From: Luke
Sent: 9/06/2023 1:40:27 PM
To: Council Northernbeaches Mailbox
Subject: Objection submission for development application DA2023/0617
Attachments: Objection to Development Proposal DA2023 0617 (2).pdf;

Please find attached an objection submission for development application DA2023/0617 (22/24 Angle Street, Balgowlah).

I, Luke Westlake, resident of 6/20 Angle Street, object to this development proposal (DA2023/0617 - 22 & 24 Angle Street). This submission details the grounds on which I object under Manly LEP 2013 and Manly DCP 2013.

Ground floor measurements (N.B, basement storey not shown)

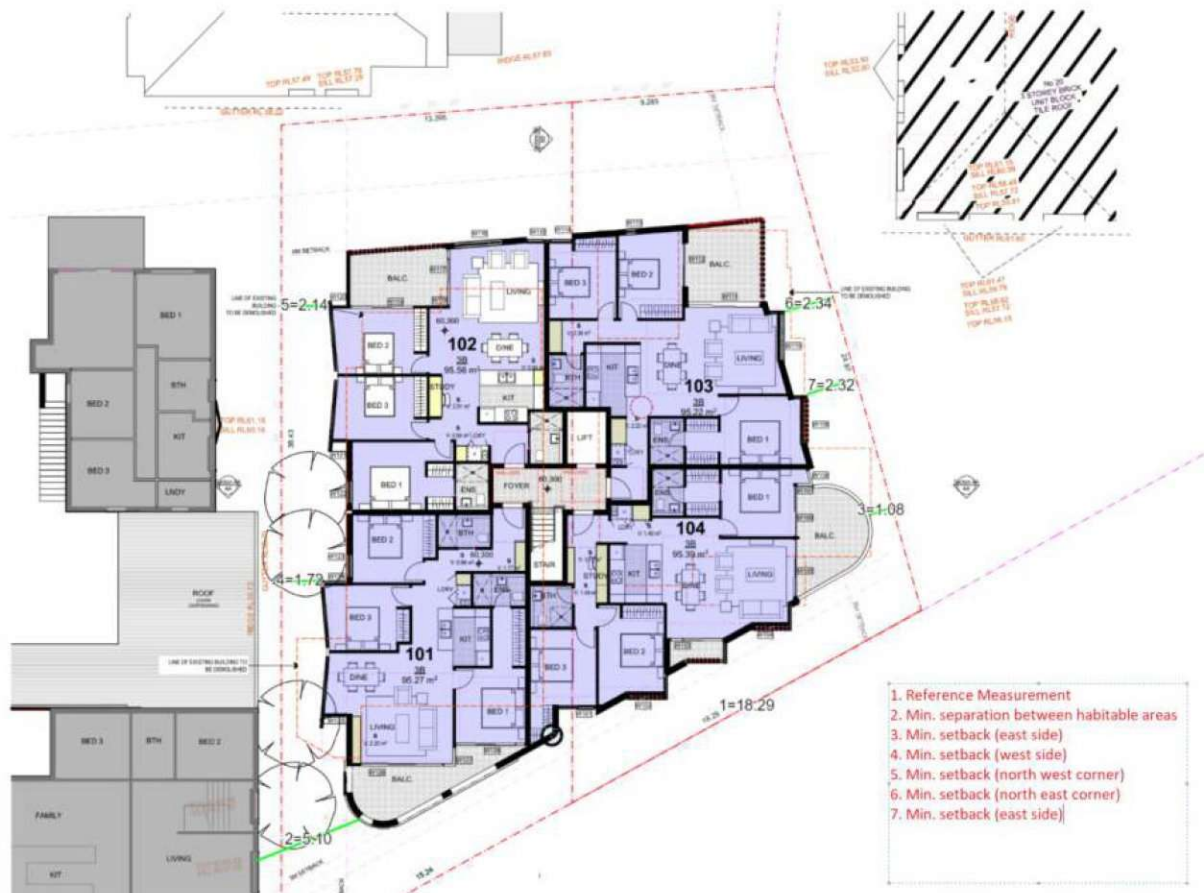
Typical building separations demonstrating rhythm and space of Angle Street.
Measurements are between walls with significant windows into habitable areas.
